Subject: Issuance of Amendment No. 39 to Facility Operating License NPF-35
and Amendment No. 31 to Facility Operating License NPF-52 - Catawba
Nuclear Station, Units 1 and 2 (TACS 66636/66637)

The amendments modify the Technical Specifications to ensure that plant operation is consistent with the design and safety evaluation conclusions of the Unit 2 cycle 2 reload safety evaluation and to reflect the addition of the Boron Dilution Mitigation System for Unit 2.

ATTACHMENT TO LICENSE AMENDMENT NO. 39

Replace the following pages of the Appendix "A" Technical Specifications with the enclosed pages. The revised pages are identified by Amendment number and contain vertical lines indicating the areas of change. The corresponding overleaf page is also provided to maintain document completeness.

FIGURE 3.1-1
 ROD BANK INSERTION LIMITS VERSUS THERMAL POWER
 FOUR LOOP OPERATION

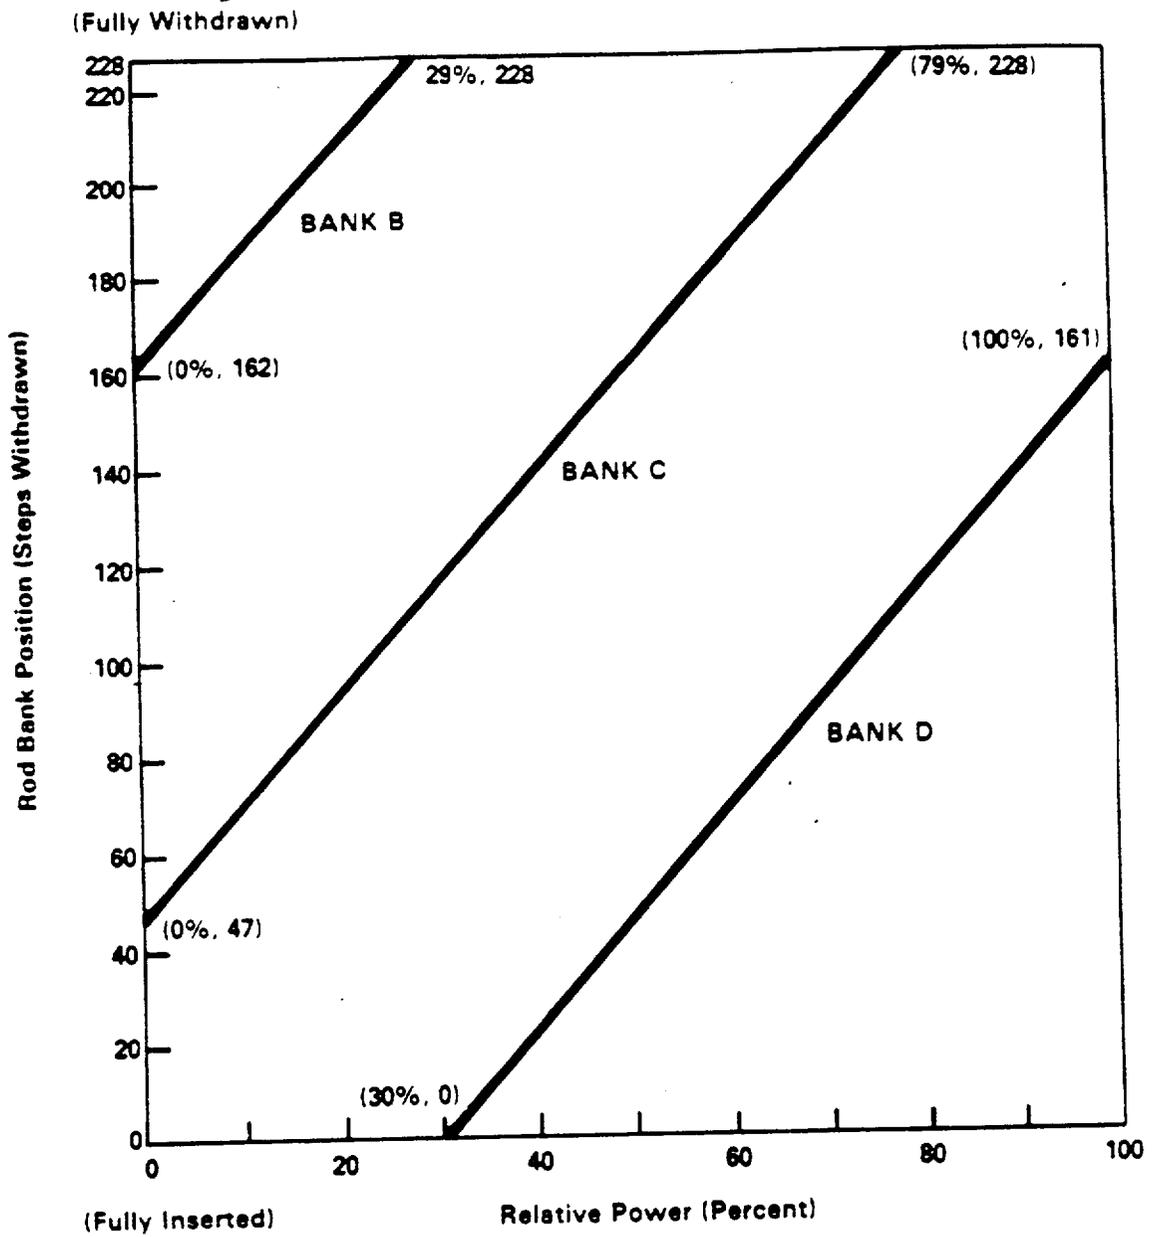
3.1.3.6 The control banks shall be limited in physical insertion as shown in Figure 3.1-1.

The RSE provides a table of Cycle 2 kinetics characteristics which are compared with the current limits based on previously approved accident analyses. The RSE also provides a table showing the results of the calculated Cycle 2 control rod worths and requirements at the most limiting condition during the cycle (end-of-life). These results include a standard 10% allowance for calculational uncertainty. From this information, the staff concludes that sufficient control rod worth will be available to provide the required shutdown margin for Cycle 2 operation. Control rod insertion limits were increased for less than 100% power for Cycle 2. Since the required shutdown margin is maintained, the TS change proposed to reflect the increased insertion is acceptable.

FIGURE 3.2-1
 AXIAL FLUX DIFFERENCE LIMITS AS A FUNCTION OF RATED THERMAL POWER

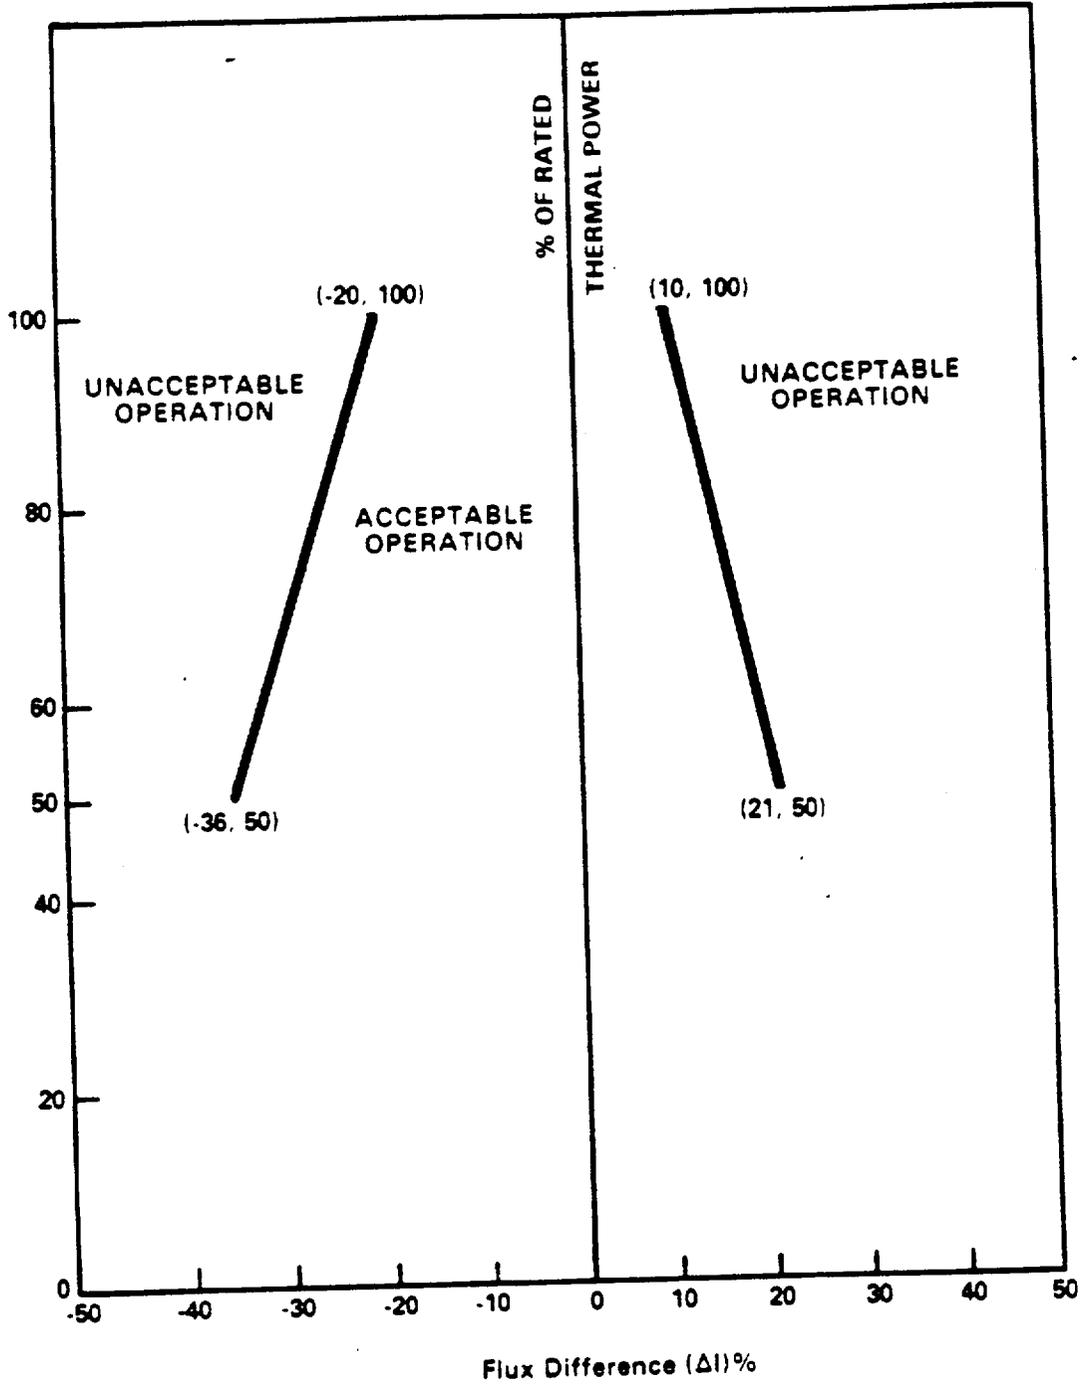
- a. the allowed operational space defined by Figure 3.2-1 for RAOC operation, or
- b. within a $\pm 3\%$ target band about the target flux difference during baseload operation.

The power distributions produced by the cycle-specific RAOC analysis were analyzed for normal operation and Condition II events. Limits on the allowable operating flux difference as a function of power level from these considerations were found to be less restrictive than those resulting from LOCA F_0 considerations. The Condition II analyses generate DNB core limits and resultant overtemperature delta T setpoints. These generated a change to the $F(\Delta I)$ function in the TSs. The change is acceptable because it results from cycle-specific calculations using approved methods (Refs. 7 and 8). Therefore, the staff concludes that the Cycle 2 thermal-hydraulic analysis is acceptable.
